This document transmits the Initial Issue of Service Bulletin V2500-ENG-72-0378

**V2500-ENG-72-0378**

ENGINE - LP COMPRESSOR – TO ANNOUNCE THE AVAILABILITY OF NEW ENGINE IDENTIFICATION PLATE WITH DESIGNATION OF ALL A5 MODEL RATINGS

Before and after alteration of Engine Identification Plate,  
Name Plate Bracket and Fastener  
Figure 1 (Sheet 2 of 2)

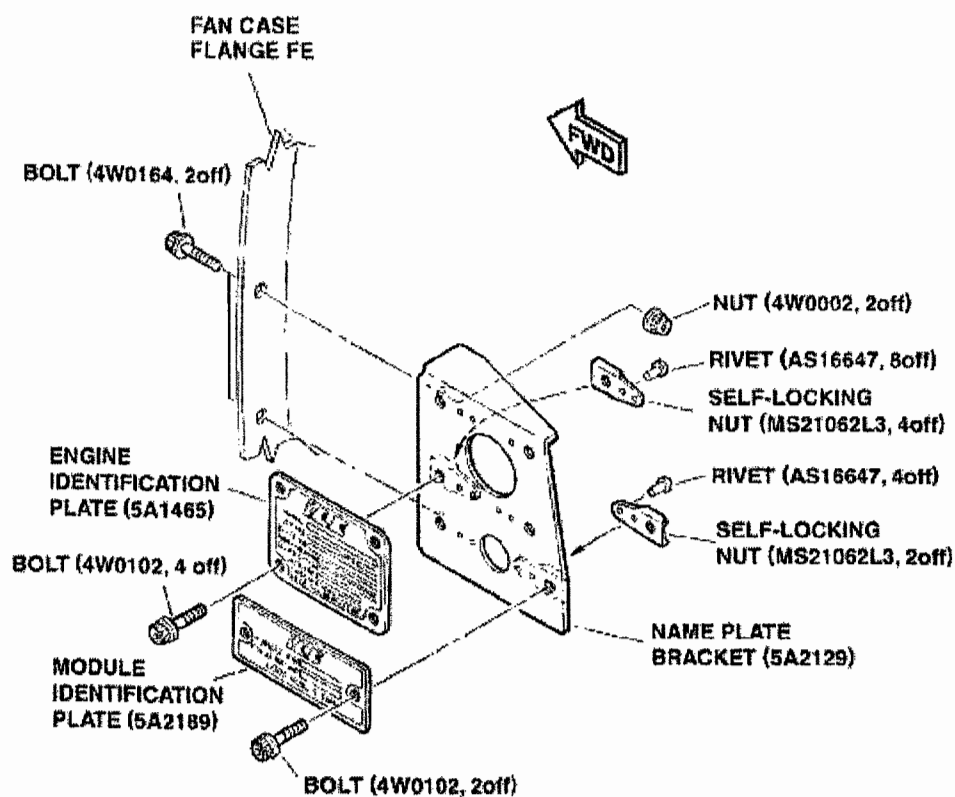
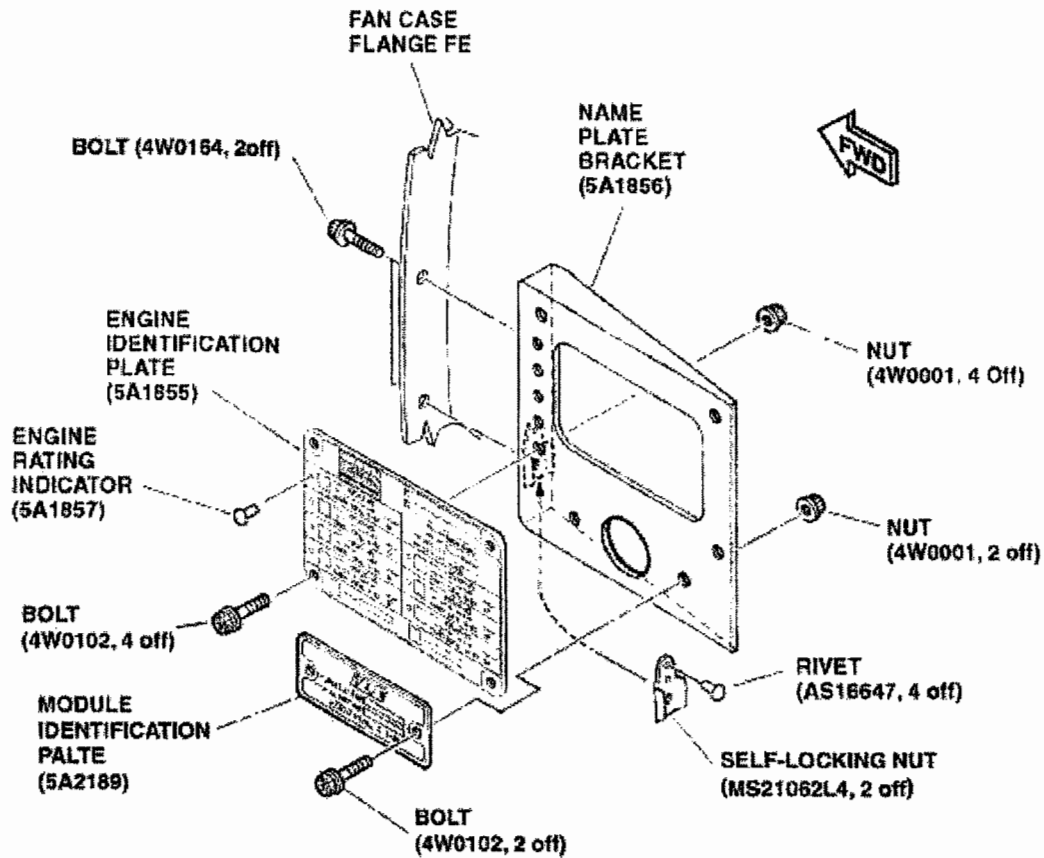
- (a) New Engine Identification Plate have all designation of A5 Engine Model ratings engraved on the plate, and a specific rating to be used is marked by placing the Engine Rating Indicator. See figure 1 and 2.

- (d) Mounting configuration of the new Engine Identification Plate to the new Name Plate Bracket is changed. The Nuts used in the new configuration are additional items. See figure 1 and 3.

- (e) Mounting configuration of the existing 5A2189 Module Identification Plate to the new Name Plate Bracket is changed. The Nuts used in the new configuration are additional items. See figure 1 and 3.

- (f) Mounting configuration of the new Name Plate Bracket to existing Fan Case is changed. The self-locking Nuts and Rivets used in the new configuration are additional items. See figure 1.

- (1) Remove the 5A2129 Name Plate Bracket and the 5A1465 Engine Identification Plate From the Fan Case (See Figure 1).
  - (a) Remove the 4W0164 Bolts (2 off) that attach the Name Plate Bracket to the Fan Case Flange FE.

- (b) Remove the 4W0102 Bolts (4 off) that attach the Engine Identification Plate to the Name Plate Bracket.
  - (c) Remove the 4W0102 Bolts (2 off) that attach the 5A2189 Module Identification Plate to the Name Plate Bracket.

- (d) Give the old Engine Identification Plate to your IAE Representative.
- (2) Install the new 5A1856 Name Plate Bracket and the new 5A1855 Engine Identification Plate to the Fan Case (See Figure 1, 2, 3 and 4).

- (a) Install the 5A1857 Engine Rating Indicator at the appropriate 'TAKE-OFF RATING/VARIANT' position in the Engine Identification Plate.
  - (b) Install the Engine Identification Plate to the Name Plate Bracket with 4W0102 Bolts (4 off) and 4W0001 Nuts (4 off).

- (c) Torque the Bolts between 36 and 45 lbfin (4,00 to 5,00 Nm).
  - (d) Install the Module Identification Plate to the Name Plate Bracket with 4W0102 Bolts (2 off) and 4W0001 Nuts (2 off).

- (e) Torque the Bolts between 36 and 45 lbf·in (4,00 to 5,00 Nm).
- (f) Install the Name Plate Bracket to the Fan Case Flange FE with 4W0164 Bolts (2 off).
- (g) Torque the Bolts between 85 and 105 lbf·in (10,00 to 12,00 Nm).

Engine Rating Indicator  
Figure 4

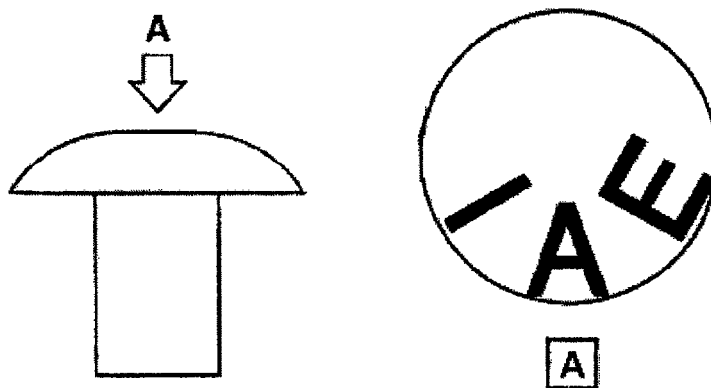
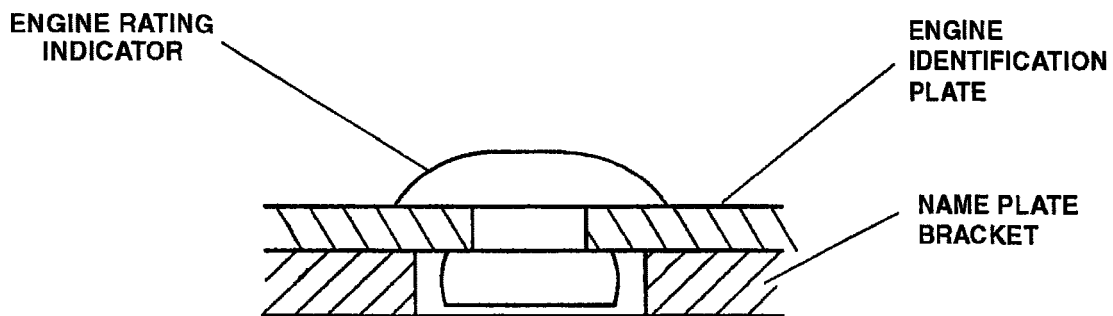
- (b) The new Engine Identification Plate is reusable type and the Engine Rating Indicator is disposable type. See figure 1, 2 and 4.
  - (c) Configuration of Fan Case is not changed.

- (2) Existing 5A1465 Engine Identification Plate, and 5A2129 Name Plate Bracket can not be reworked to new parts.
- (3) The Engine Rating Indicator is an additional item. See figure 1 and 4. For the additional item, ATA No.73-22-36 is newly assigned.
